# **Building Code of Australia**

## **Assessment Report**

**Project Address: 7 Martin Close, East Maitland**

Report Number: RE200033

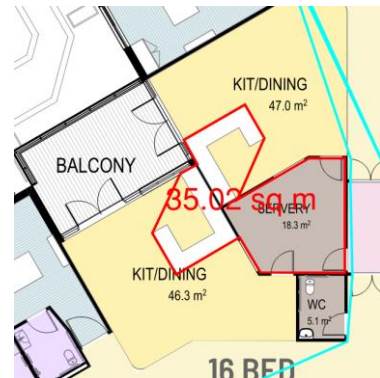
The following ancillary areas exceed the above floor area requirements and require smoke proof walls:

Ground floor

- 1. Western double kitchen + servery 32m<sup>2</sup>

Level 1

- 2. Western double kitchen + servery 32m<sup>2</sup>

Level 2

- 3. Western double kitchen + servery 35m<sup>2</sup>

Performance justification is proposed

D1.4

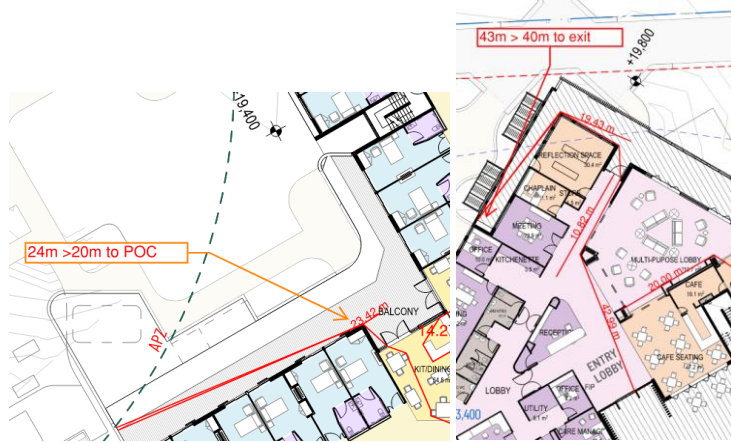
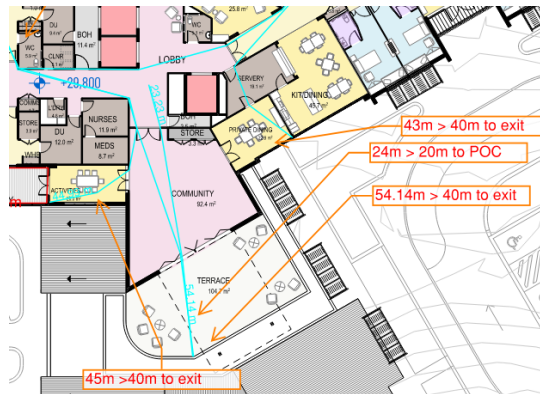
Generally, the exit travel distances throughout the building meet the requirements of this Clause, with the exception of the following areas:

Ground Floor

Common balcony (South west wing)

- 24m > 20m to POC

Walkway to the rear of the Chaplain

- 43m > 40m to exit

Level 2

Terrace

- 24m > 20m to POC
- 54.2m > 40m to exit

Community room

- 48m > 40m to exit

Private dining (off community room)

- 43m > 40m to exit

Activities room (off community room)

- 45m > 40m to exit

Performance justification is proposed

D2.17

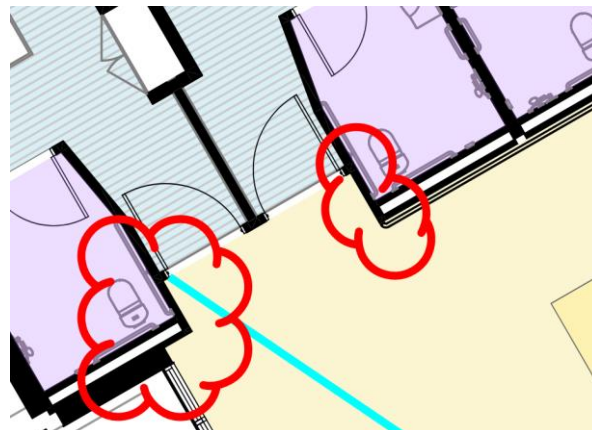
Handrails have not been provided in the following areas:

1. Lower ground (wellness area)
2. Ground level – Residential areas
3. Level 2 – Residential areas

4. External stairs in lieu of FIS
5. Common lobby on all levels;

A design change is required.

F4.8

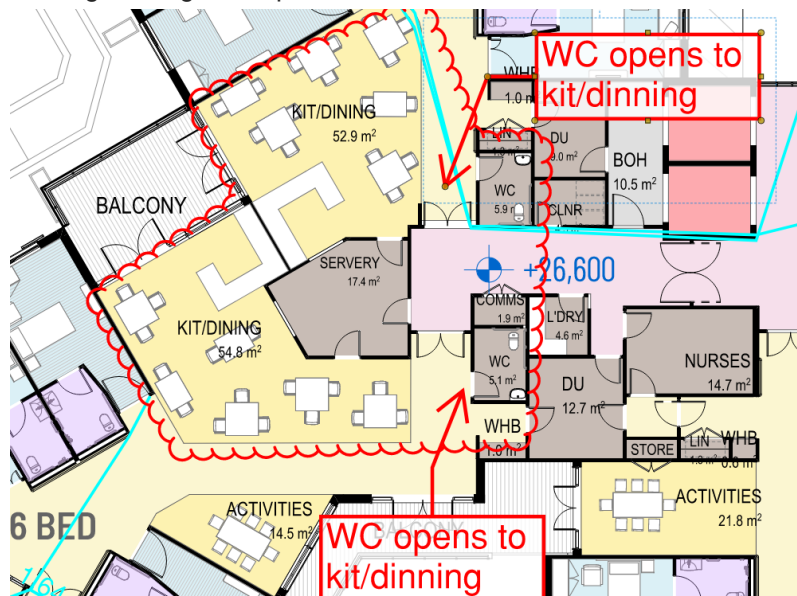
The following sanitary compartments do not comply with the provisions of this Clause:

Lower ground floor

1. ACC WC/Shower in Dinning (day respite)

Ground Floor

2. WC - southern wing opposite Kit/dinning
3. WC - western wing opposite Kit/dinning

Level 1

4. WC - southern wing opposite Kit/dinning
5. WC - western wing opposite Kit/dinning

Level 2

6. WC - western wing opposite Kit/dinning

A design change is required.

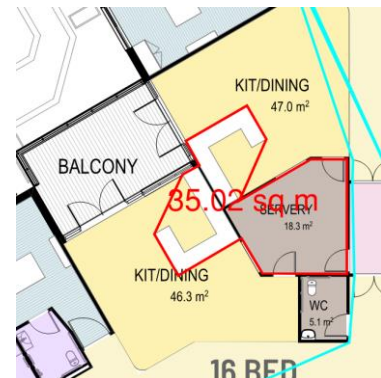
2. Western double kitchen + servery 32m<sup>2</sup>

Level 2

3. Western double kitchen + servery 35m<sup>2</sup>

Performance justification is proposed

D1.4

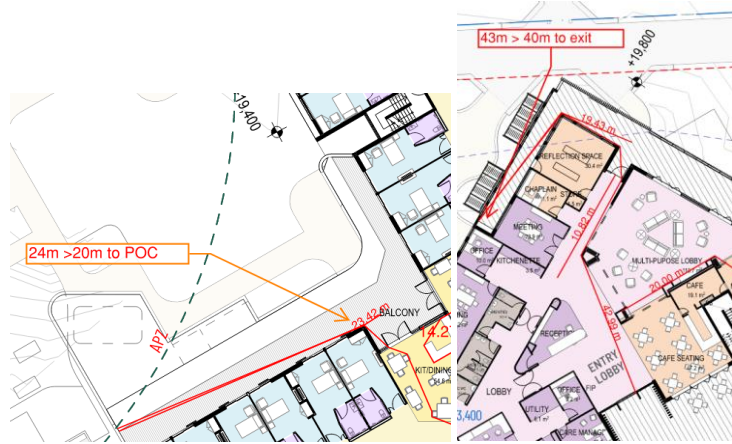
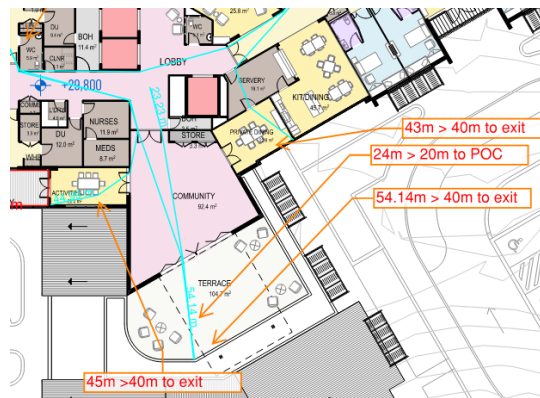
Generally, the exit travel distances throughout the building meet the requirements of this Clause, with the exception of the following areas:

Ground Floor

Common balcony (South west wing)

- 24m >20m to POC
- 54.2m > 40m to exit

Community room

- 48m > 40m to exit

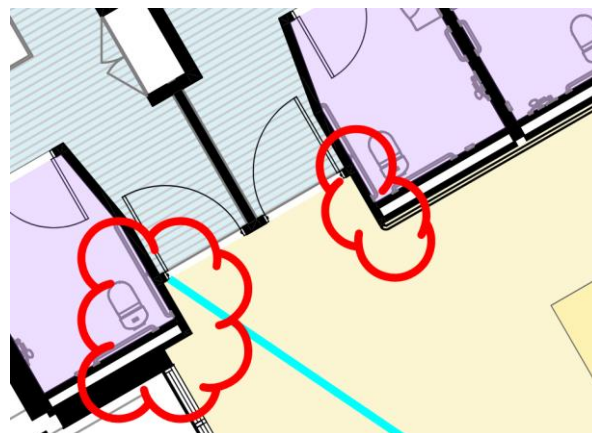
Handrails have not been provided in the following areas:

1. Lower ground (wellness area)
2. Ground level – Residential areas
3. Level 2 – Residential areas
4. External stairs in lieu of FIS
5. Common lobby on all levels;

A design change is required.

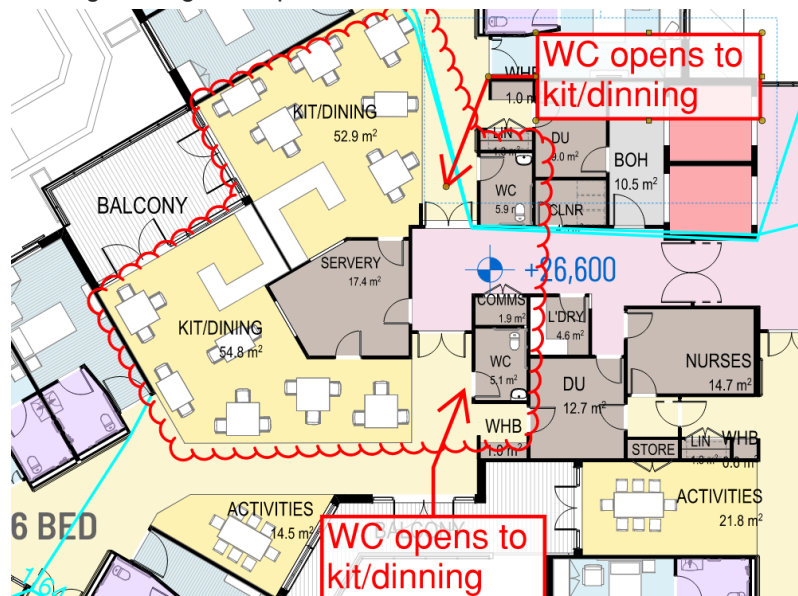
Level 2

6. WC - western wing opposite Kit/dinning

A design change is required.
